## VALUE ENGINEERING PROPOSAL

DESCRIPTION: Provide a Land-Side Earth/Stone Berm to the Sheetpile Bulkhead Wall

NEW BEDFORD HARBOR SUPERFUND SITE  
UPPER AND LOWER HARBOR (OU#1)  
NEW BEDFORD, MASSACHUSETTS

DRAWING NO. 1: Current CDF "D" Plan A-1

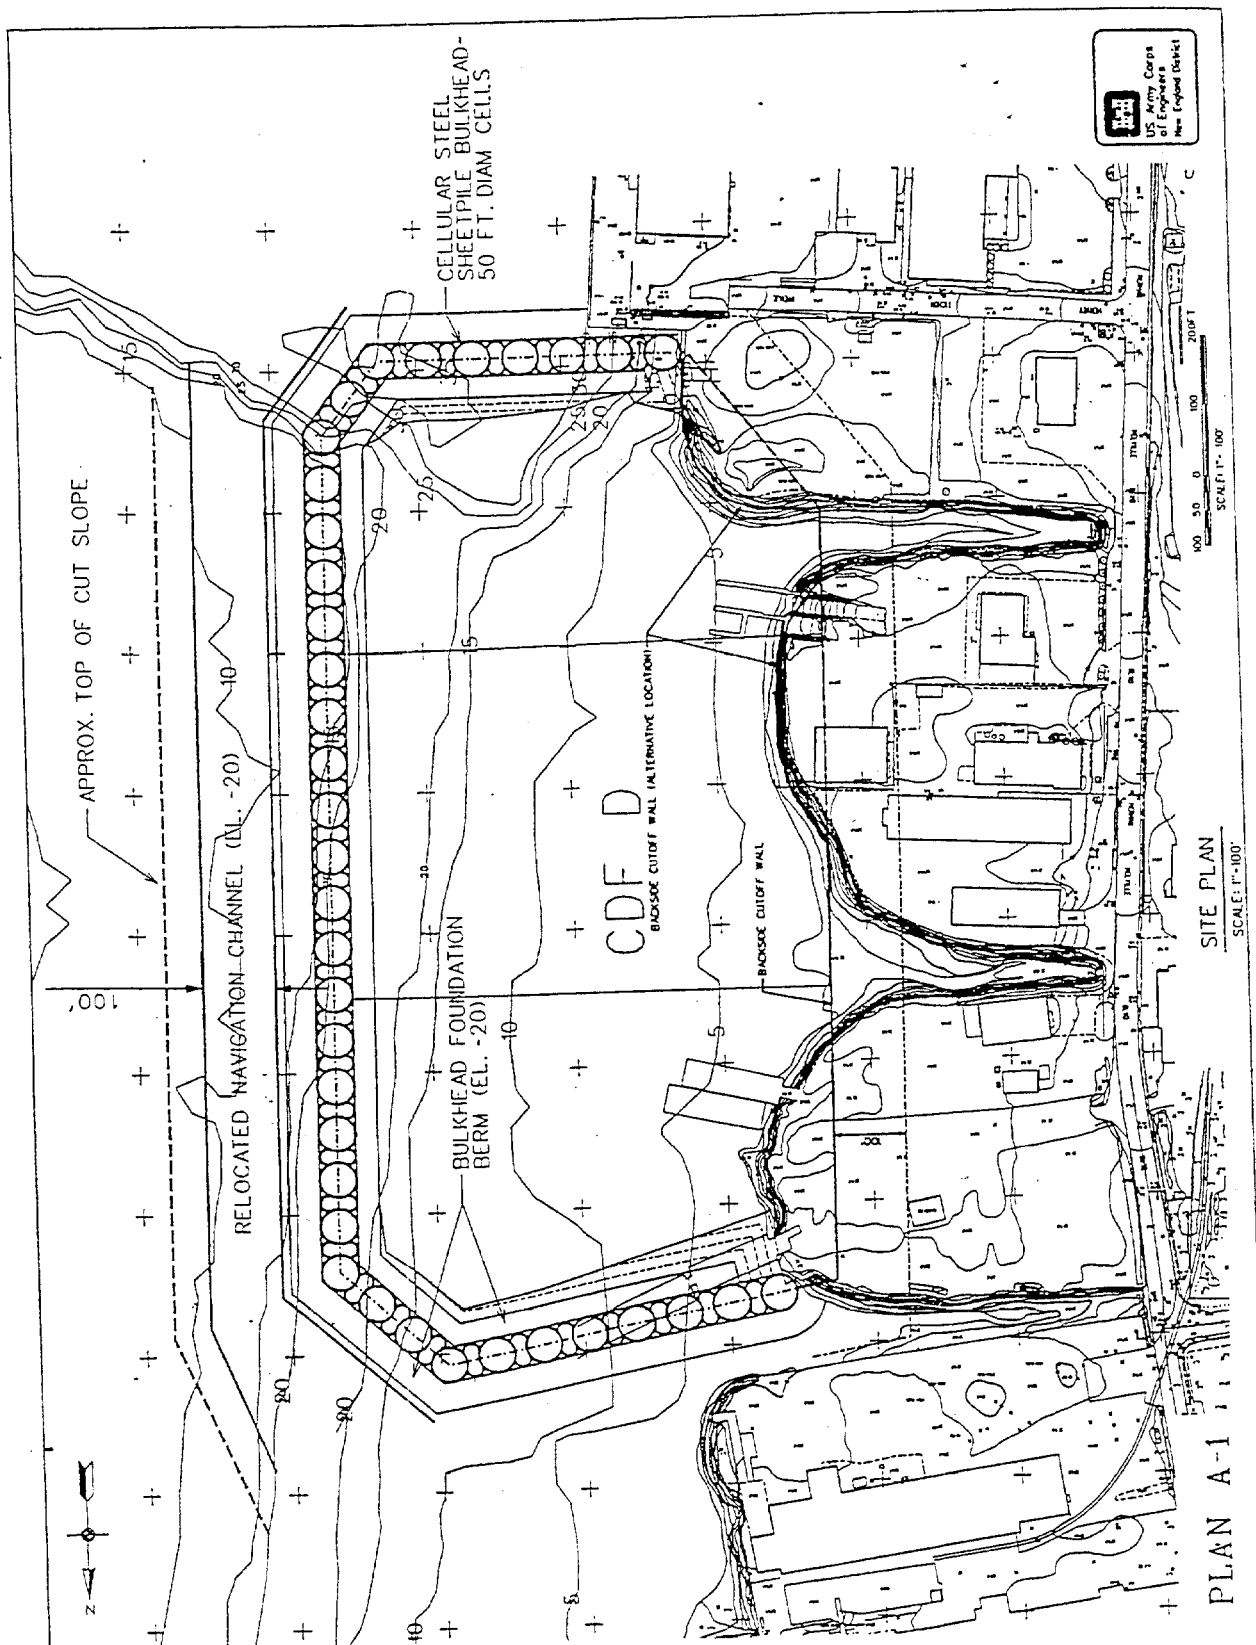
The current plan provides a steel sheet pile bulkhead wall for three sides of the CDF. Construction steps include pre-dredge unsuitable soils, backfill foundation with granular fill, driving sheetpile cells, and filling the cells. See Drawing No. 1: CDF "D" Alternative A-1 Plan, Drawing No. 2: CDF "D" Alternative A-1 Section.

DRAWING NO. 3: Proposed CDF "D" Plan A-1

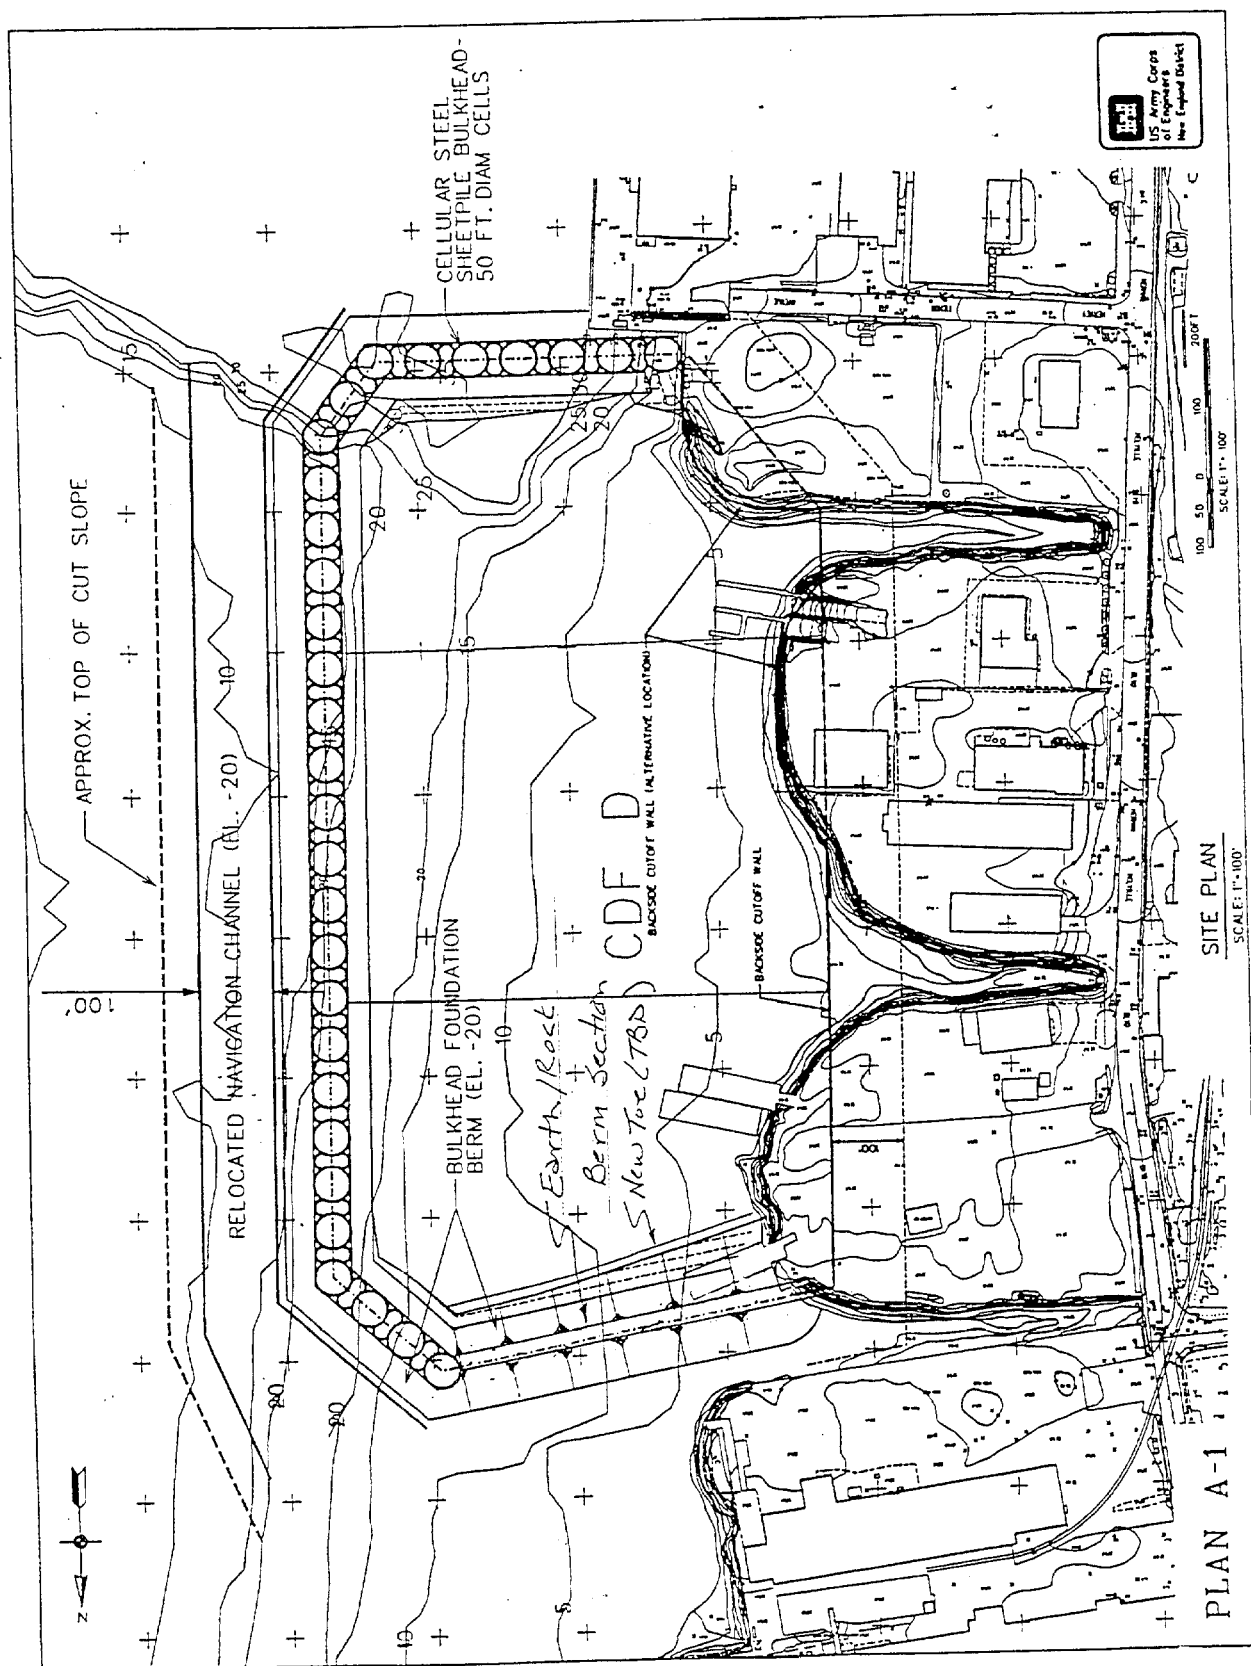
Recommend using a land-side earth/stone berm for the first 500 LF for the north containment berm. Plan A-1 is considered as the base plan for this alternative. Berm slopes may vary from 2H:1V to 3H:1V (actual to be determined). See Drawing No. 1: CDF "D" Alternative A-1 Plan, Drawing No. 2: CDF: "D" Alternative A-1 Section. Keep excavation of unsuitable foundation and backfill of new foundation.

The proposed earth/stone berm system can be developed for placement as the north CDF containment wall (500 LF). Issues to be developed include minimizing excavation and establishing the berm slope for the exposed wall (3H:1V vs. 2H:1V). The land based end-dump fill method is simpler and faster than sheetpile cells. A minimum of storage volume is lost. Additional design effort should be well worth the resulting benefits realized. A riprap face has been provided to the exposed face of the berm.

DRAWING NO. 1

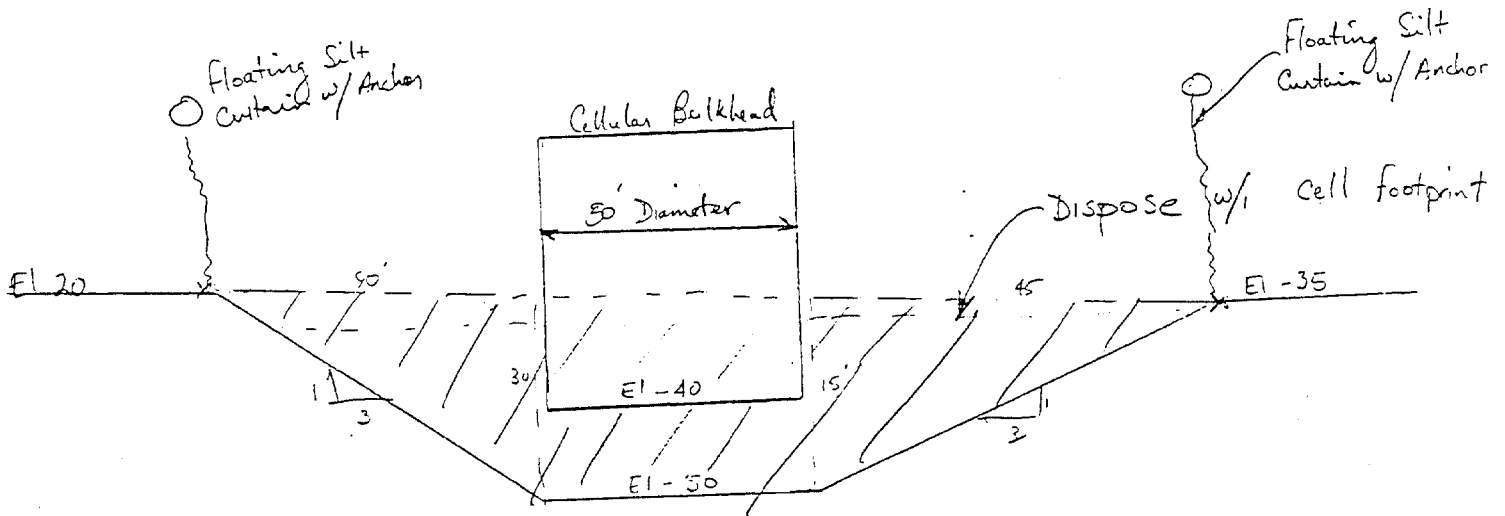
Prior to installation of cellular sheet-pile bulkhead, the foundation (along with side slopes) would be dredged. The dredged material would be stored in CDF "D" storage area. Migration of contaminants would be controlled by a floating silt curtain.

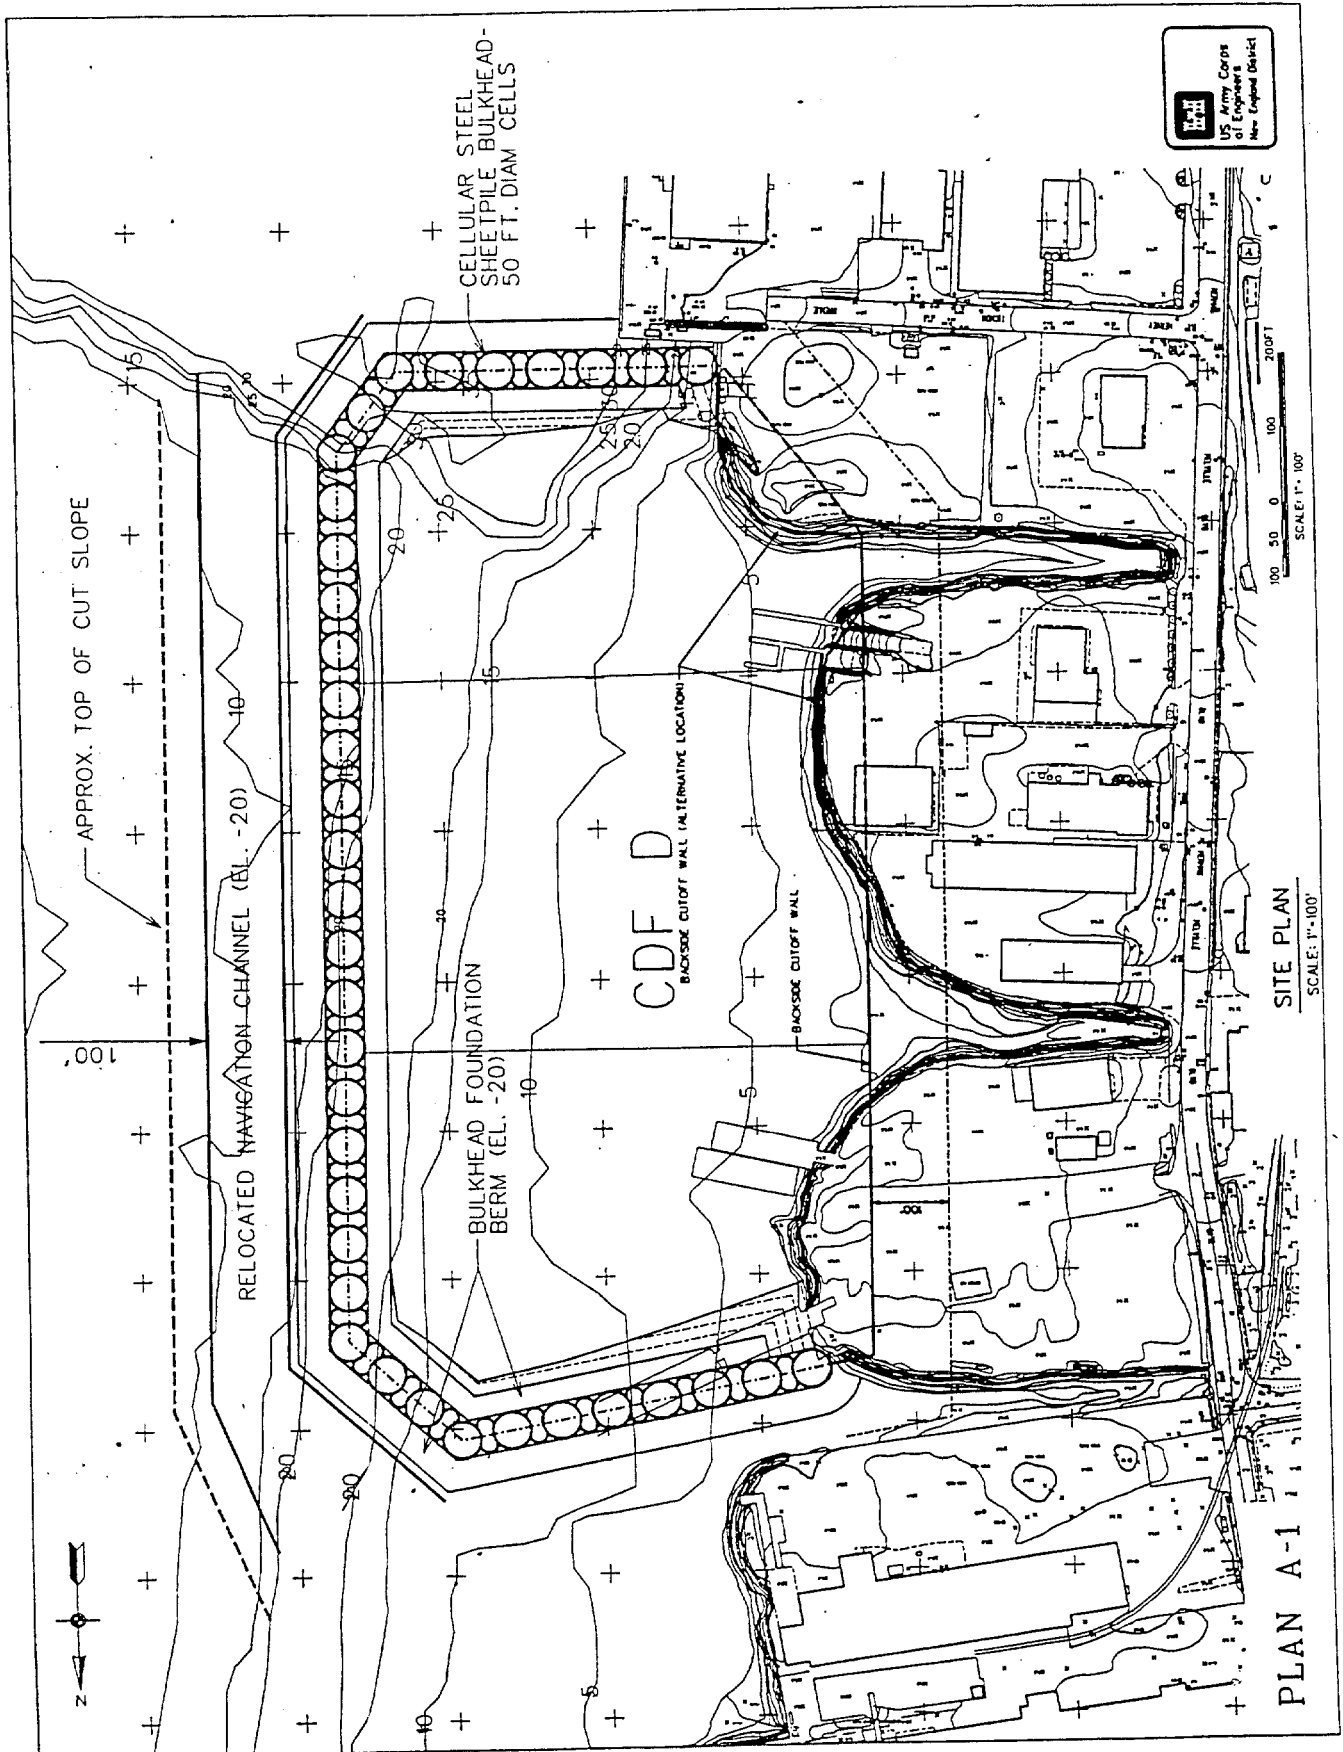
Foundation materials, both contaminated layer and pre-dredge, for cellular sheet-pile bulkhead wall will be excavated , transported and disposed at an offsite landfill (See Drawing No 1).

DRAWING NO. 2

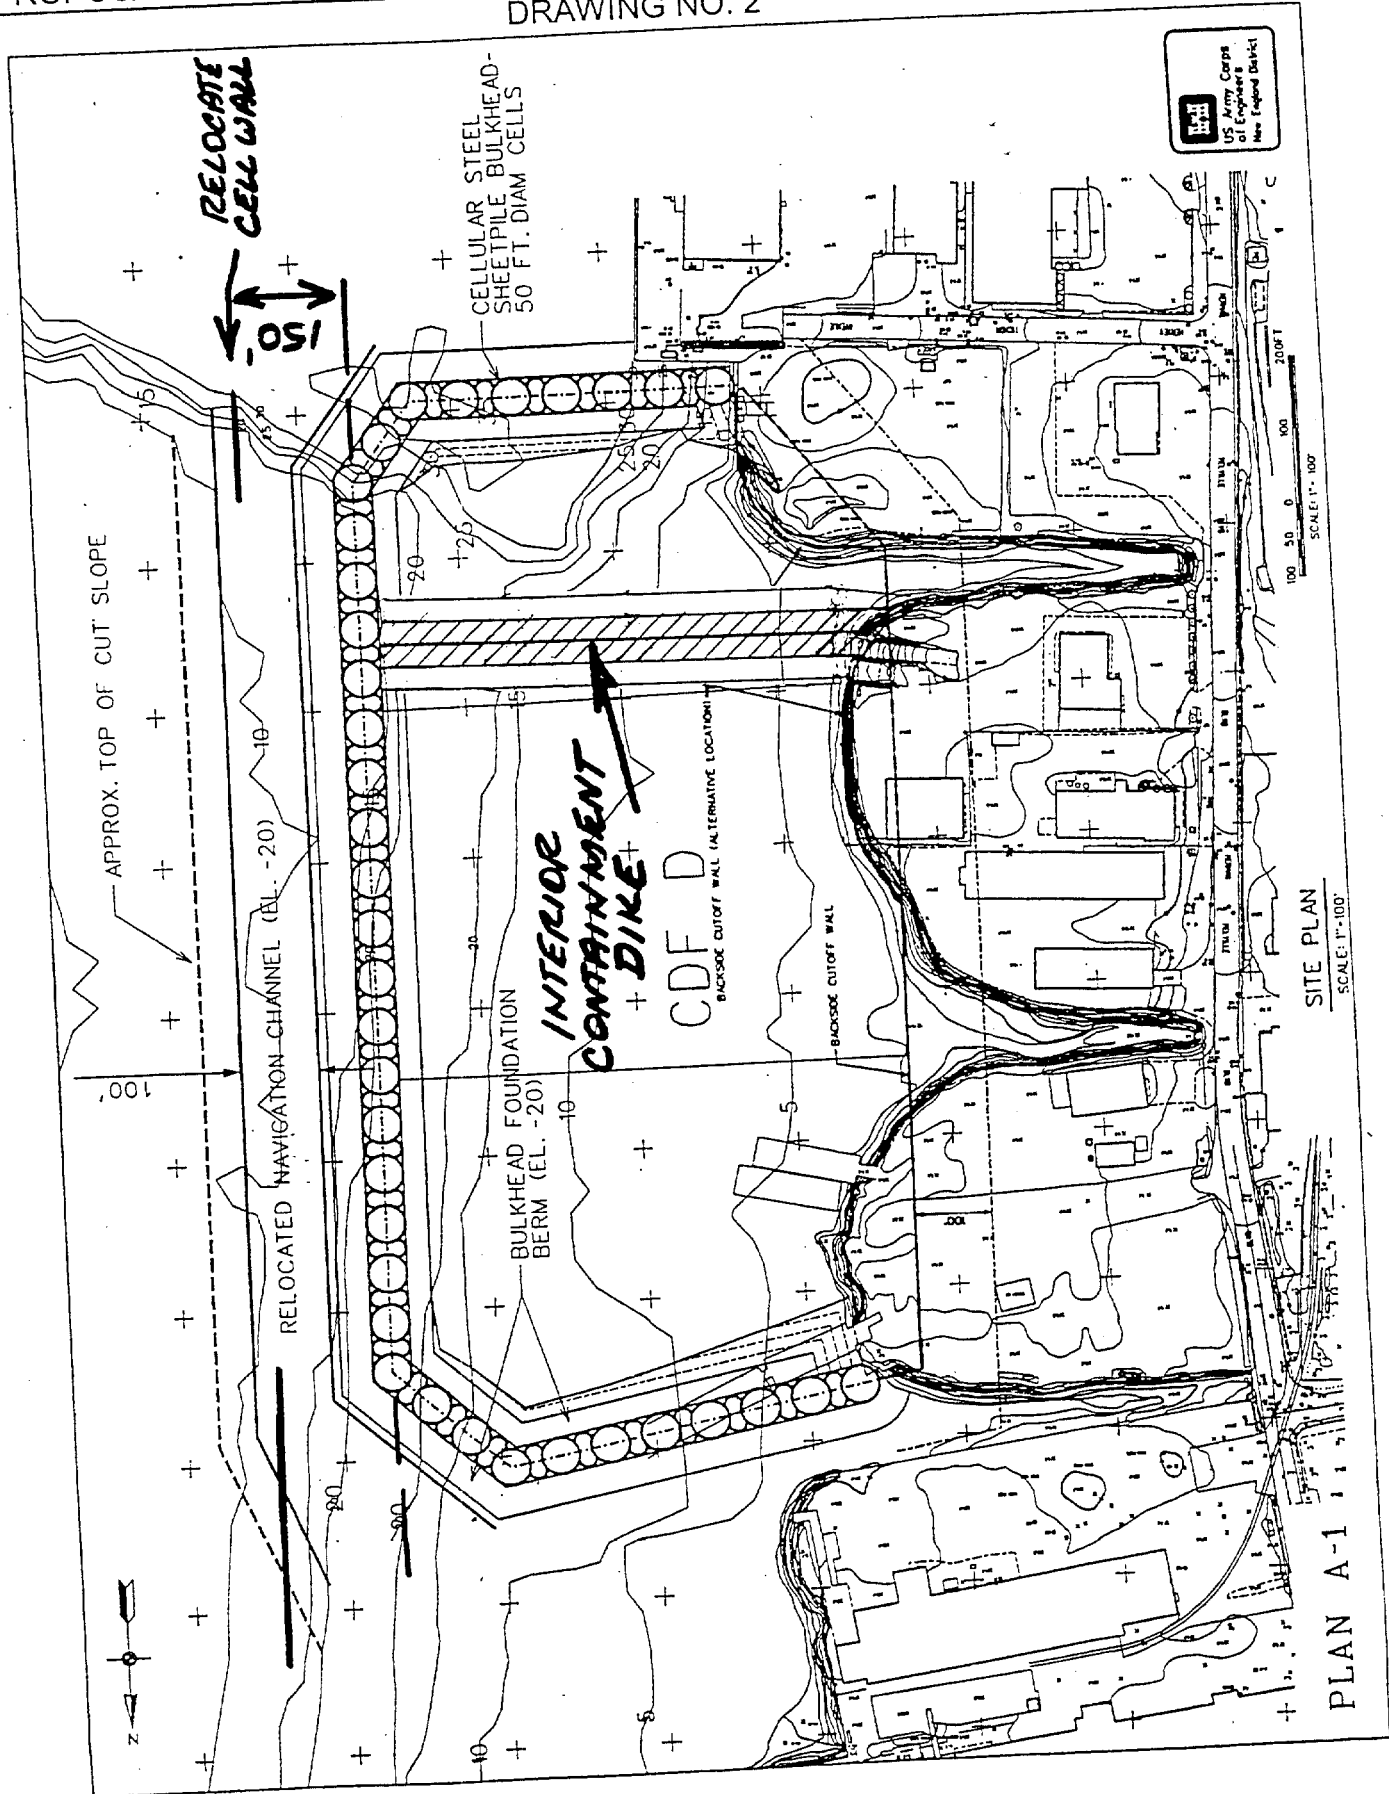
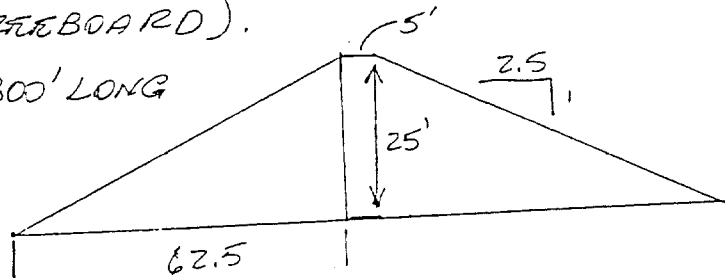
As installation of cellular sheet-pile bulkhead progresses, begin construction of an interior compartment by placing an adjacent earthen containment dike within CDF "D". Material from the foundation of the first 1400 (approximate) feet of cellular wall will be temporarily stored on site and later relocated into the interior compartment. Size of this interior compartment will be approximately 650 feet x 400 feet x 25 feet average depth. Assuming 3 feet freeboard , this will provide a containment area approximately 22 feet deep. Continue dredging of the foundation for the rest of the bulkhead and place this pre-dredge material and contaminant layer from the footprint of the cellular wall directly into the interior compartment. Reduced capacity within the original CDF "D" footprint, total of 240,000 cy is compensated for in this proposal by moving the harbor side wall approximately 150 feet harborward, thereby increasing the size of the CDF (See Drawing No 2).

Construction of an interior compartment can be done concurrently with cellular wall construction. Material from the initial 1400 (approximate) feet of cellular wall foundation can be temporarily stored on site in the swales or other location, and relocated back into the compartment. Cellular wall foundation material, both contaminated and pre-dredge, will be moved a short distance and placed within the compartment of CDF "D". Offsite transportation or disposal costs will be reduced.
